Development Permit Panel

1. **Development Permit 15-694616**

PROPERTY LOCATION: 10199 River Drive

Parc Riviera Context Map Development Application History DP 15-694616

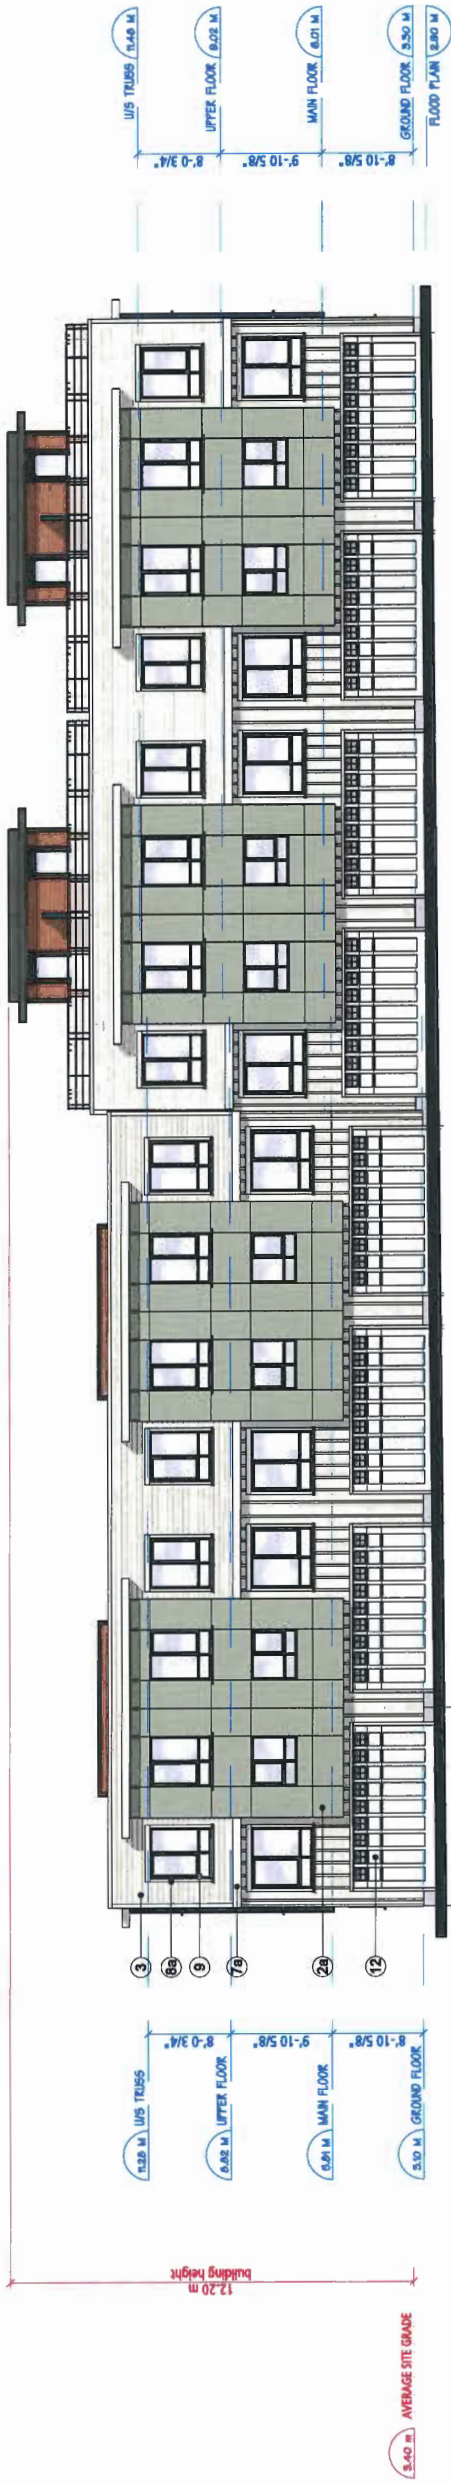
- Applicant needs to provide clarity to the rationale for using vertical as opposed to horizontal banding in some townhouse buildings, e.g. in Buildings 15 and 16 – ***The form and character of buildings 15 and 16 are contemporary to match with and provide transition from the modern form of Building G of Phase 1.***

3 36" HT. WOOD FENCE

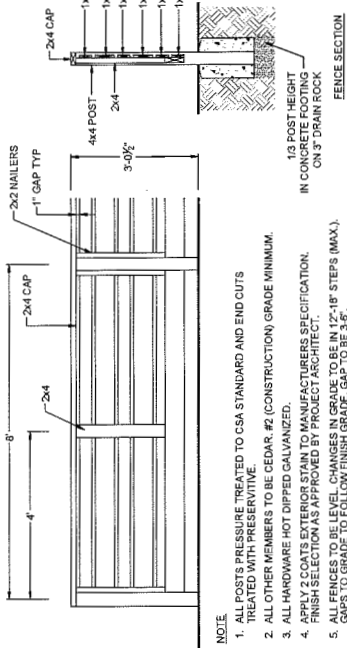
- Appreciate the interior planting in the proposed development – *Noted.*
- Consider lowering the proposed 42-inch rail fence adjacent to the park to provide better visual connection – *Incorporated. Fence height reduced to 36-inch height.*
